Consultant	Wahib Medanat Consultant Engineer	Rep No.	12-25062022
Contractor	Derar Saraireh & Sons for Engineering & Contracting	Tender No.	(11/2019/USAID/SKEP/3/S) Schools for a Knowledge Economy Project (SKEP) - Phase (3) Package (1, 2)
Site Name	Al Khansa' Basic Mixed School- Al Balqa	Day/ Date	Sat. 25/06/2022
Duration of Project	450 Calendar Days	Total Project Budget	9,789,417.840 JD

Visit Notes

(Figure: 10)

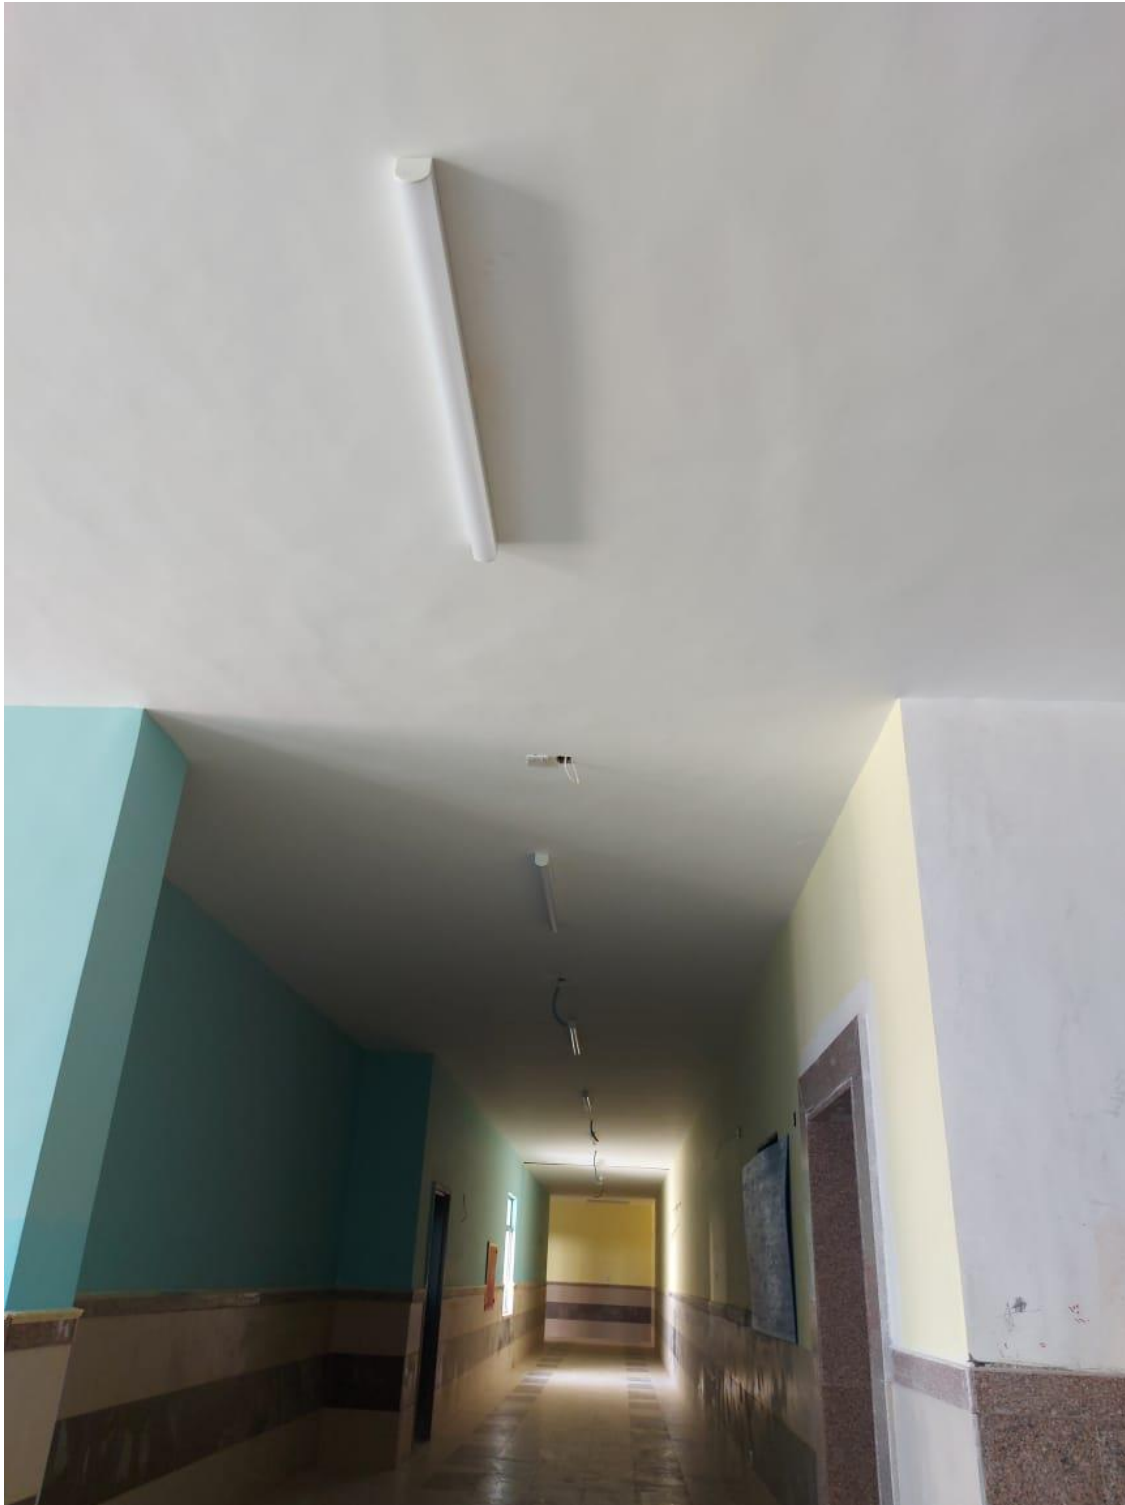
The team observed that the relation between the Plaster limit and flashing requires refinement

(Figure: 14)

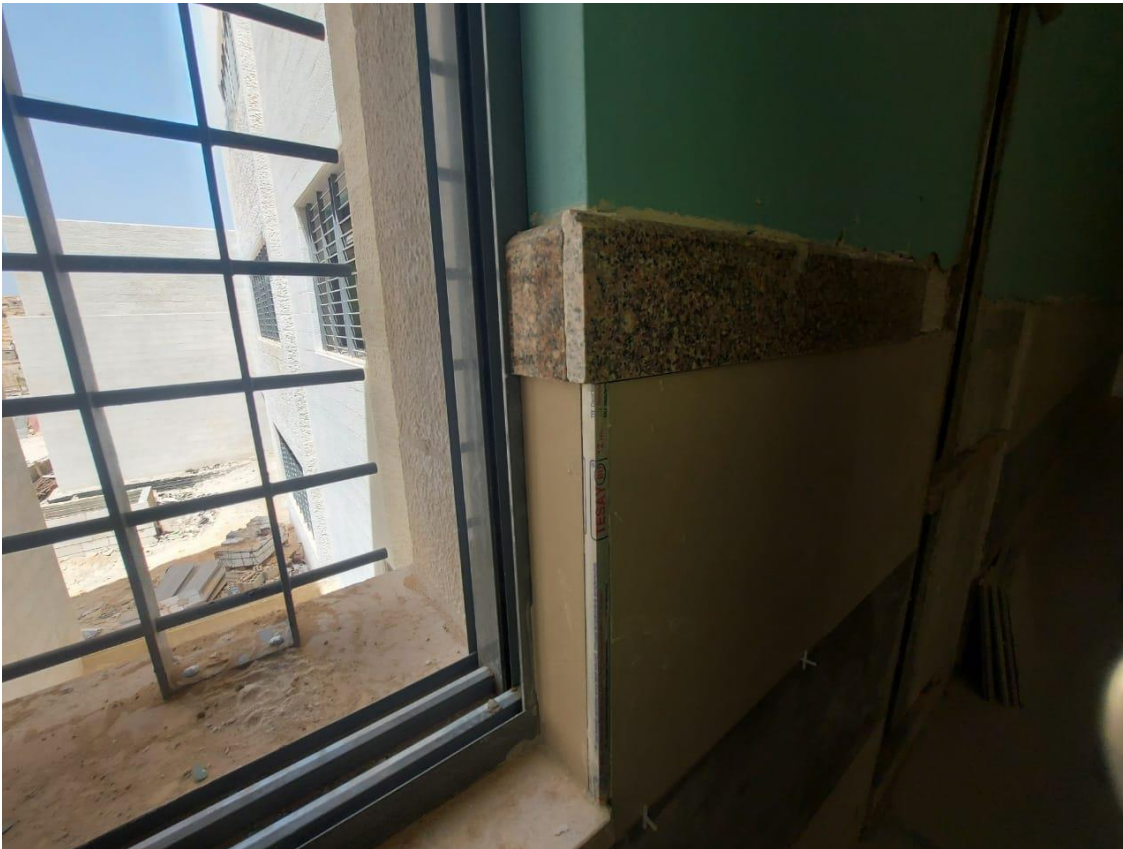
The team observed that there is some waving in the plastering and painting at the corridors and ceilings. The Contractor was requested to rectify
